STORM PROFILE
△ (CB#1 TO CB#43 LINDVOG RD. DOWNSTREAM CONNECTION)
 SCALE: HORIZ. 1"=30'
 VERT. 1"=6'

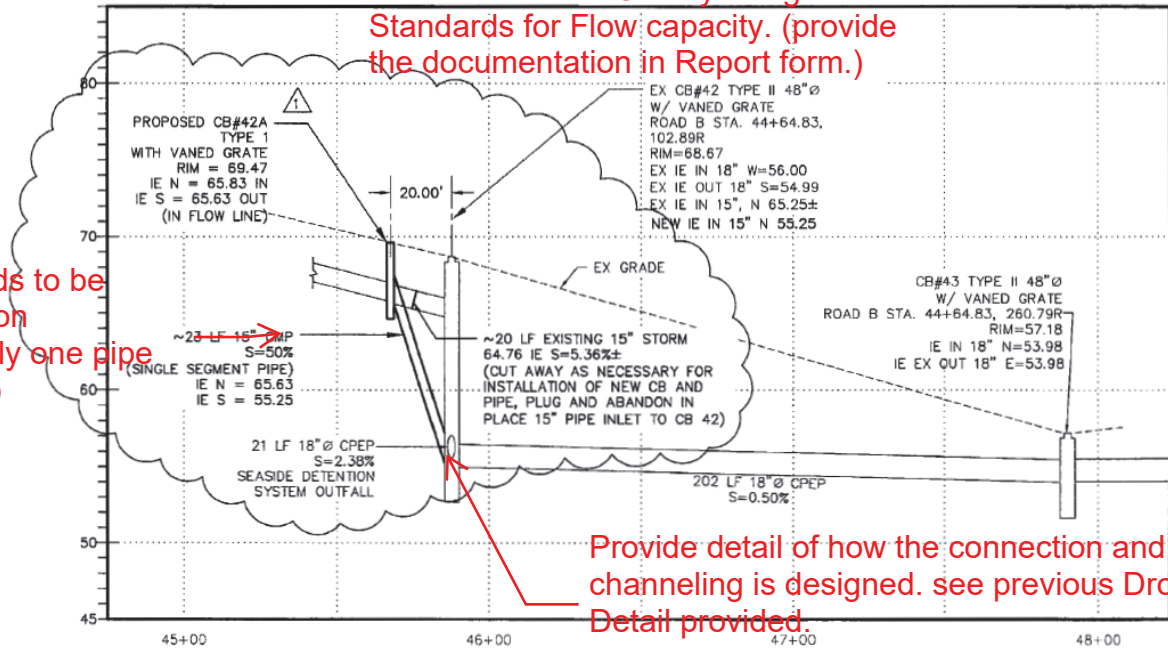
- 1.) Apply for an Addendum.
- 2.) Provide the Certification from the engineer regarding the revised design meets the County design Standards for Flow capacity. (provide the documentation in Report form.)

This needs to be Ductile iron (preferably one pipe segment)

Provide detail of how the connection and channeling is designed. see previous Drop Detail provided.
